Work Order ID 157429

DART SERVICE INSTRUCTION

TO AMEND INSTALLATION INSTRUCTIONS IIN-D117-762 REV. E AND
INSTRUCTIONS FOR CONTINUED AIRWORTHINESS ICA-D117-762 REV. 4

A	NEW ISSUE	RF	17.01.09
REV.	DESCRIPTION	BY	DATE
DESIGN	RF	DART AEROSPACE, LTD EUGENE, OR	
DRAWN	RF		
CHECKED	WK	DRAWING NO.	REV.A
MFG. APPR.	N/A	DSI 9771	SHEET 1 OF 2
APPROVED	HS	TITLE	SCALE
DE APPR.		GHL UPGRADE KIT	NTS
DATE	17.01.09	COPYRIGHT ©2017 BY DART AEROSPACE USA, INC THIS DOCUMENT IS PRIVATE AND CONFIDENTIAL AND IS SUPPLIED ON THE EXPRESS CONDITION THAT IT IS NOT TO BE USED FOR ANY PURPOSE OR COPIED OR COMMUNICATED TO ANY OTHER PERSON WITHOUT WRITTEN PERMISSION FROM DART AEROSPACE, LTD.

FIGURE 1 - GHU UPGRADE INSTALLATION

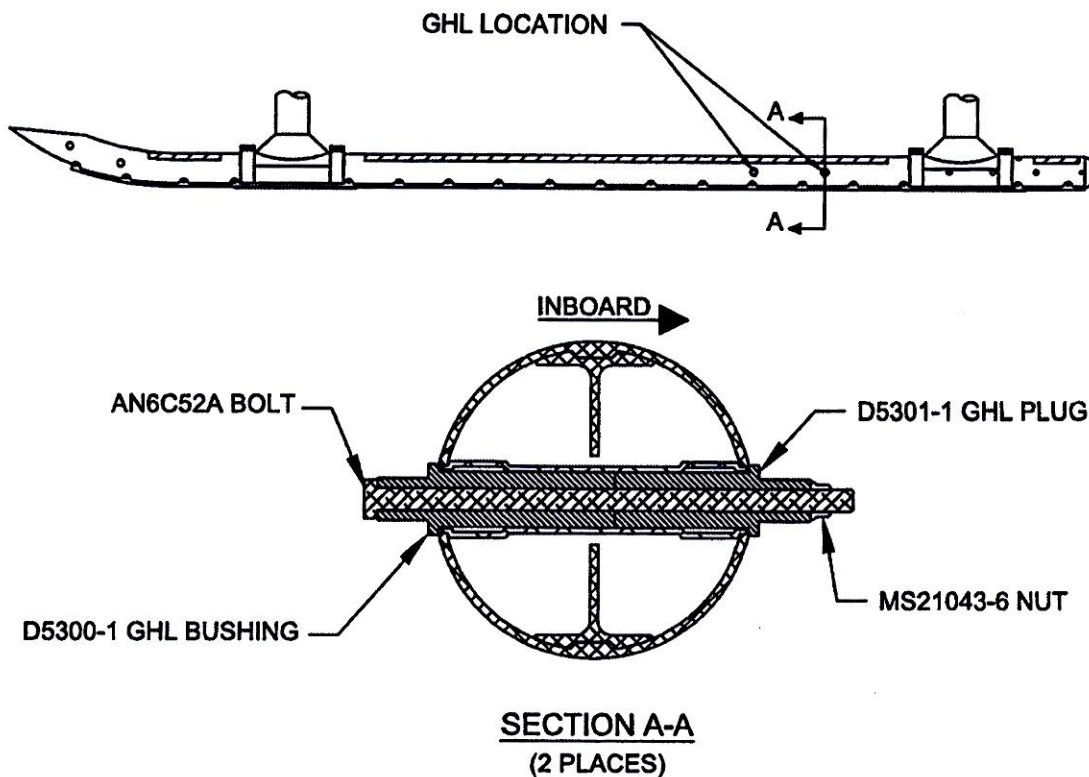
The purpose of this Dart Service Instruction (DSI) is to replace the ground handling lugs (D3864-1 Bushings, AN6C51A Bolts and MS21043-6 Nuts) on the D117-762-XXX Skidtubes with a structurally superior lug design (D5300-1 Bushings, D5301-1 Plugs, AN6C52A Bolts, MS21043-6 Nuts) as shown in Figure 1. The new hardware will be included in D117-762-011 @ CHG 004 and subsequent.

- 2.1 Loosely install (qty 2) D5300-1 GH L Bushing & (qty 2) D5301-1 GH L Plug wet with Proseal 890 or MIL-S-8802 Class B2 Sealant in location shown in Figure 1.
- 2.2 Install (qty 2) AN6C52A Bolts and (qty 2) MS21043-6 Nuts in accordance with Figure 1. Clean up squeezed out Proseal and apply fillet seal around D5300-1 & D5301-1.
- 2.3 Torque AN6C52A Bolts 160 - 190 in-lbs (18.1 - 21.5 N-m).

ITEM	QTY -011	PART NUMBER	DESCRIPTION
	X	D117-762-011	SKIDTUBE INSTALLATION
50	2	AN6C52A	BOLT
51A	2	D5300-1	GH L BUSHING
51B	2	D5301-1	GH L PLUG
52	2	MS21043-6	NUT

PART NUMBER	DESCRIPTION
	-011		
	X	D117-762-011	SKIDTUBE INSTALLATION
50	2	AN6C51A	BOLT
51	4	D3864-1	BUSHING
52	2	MS21043-6	NUT
